SUBJECT: TURKEY POINT NUCLEAR GENERATING UNIT NOS. 3 AND 4 – SAFETY
EVALUATION FOR RELIEF REQUEST NO. 3 FOR FIFTH 10-YEAR
INSERVICE INSPECTION INTERVAL – ALTERNATIVE FOR EXAMINATION
OF SNUBBERS (CAC NOS. MF6386 AND MF6387)

SAFETY EVALUATION BY THE OFFICE OF NUCLEAR REACTOR REGULATION

RELIEF REQUEST NO. 3

TURKEY POINT NUCLEAR GENERATING UNIT NOS. 3 AND 4

Figure 1

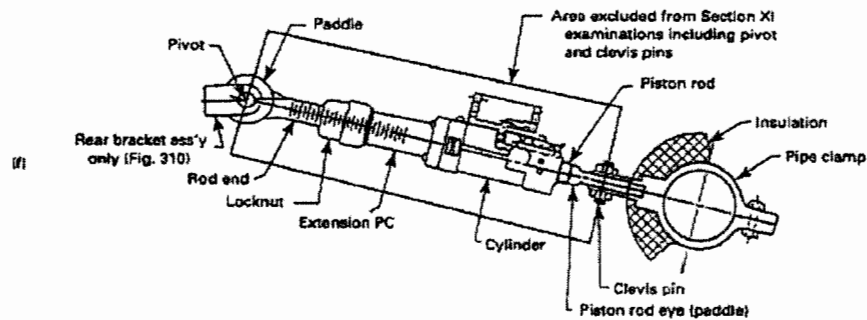
The Turkey Point snubber program for the fifth 10-year ISI intervals is based on the ASME OM Code, 2004 Edition with 2005 and 2006 addenda; whereas the visual inspection of attachments for snubber attachment hardware (i.e., pin-to-pipe and pin-to structure, excluding integral attachments) is based on the ASME BPV Code, Section XI, 2007 Edition with 2008 Addenda. Snubbers (pin-to-pin) were removed from the ASME BPV Code, Section XI in the 2006 Addenda. The 2007 Edition through the 2008 Addenda of the ASME BPV Code, Section XI contains Figure IWF-1300-1(f) that depicts the examination boundaries for snubber (pin-to-pin) and attachments (see Figure 1 below).

The component supports include snubbers (pin-to-pin) and their attachment hardware (pin-to-pipe and pin-to-structure), excluding the integral attachments. The examination and inspection of the snubbers (pin-to-pin) are to be performed per Subsections ISTA and ISTD of the ASME OM Code. However, examinations and inspections of support attachment hardware (pin-to-pipe and pin-to-structure, excluding integral attachments) are to be performed as specified in paragraphs IWF-1220 and IWF-2000 of the ASME BPV Code, Section XI. The licensee stated that having two similar sets of requirements for the visual examination and inspection for the same component supports (i.e., one for snubbers and another for their attachments and hardware), would require the performance of redundant examinations and cause unnecessary confusion in sample selection, data collection, and documentation of these examinations.

- (1) The ASME BPV Code, Section XI, 2007 Edition including the 2008 Addenda, Figure IWF-1300-1(f) specifies the boundaries for the visual examination of snubbers (pin-to-pin) and snubber attachment hardware (pin-to-pipe and pin-to-structure, excluding integral attachments). Examination requirements for snubbers (pin-to-pin) are located in the ASME OM code. Examination requirements for snubber attachment hardware are located in the ASME BPV Code, Section XI. The licensee proposed to perform the visual examination of snubbers and associated attachment hardware (pin-to-pipe and pin-to-structure, excluding integral attachments) along with snubber (pin-to-pin) visual examination in the Snubber Program.

Based on this evaluation, the NRC staff finds that the licensee's proposed alternative for visual examination of snubbers and snubber attachment hardware using the Snubber Program provides an acceptable level of quality and safety.
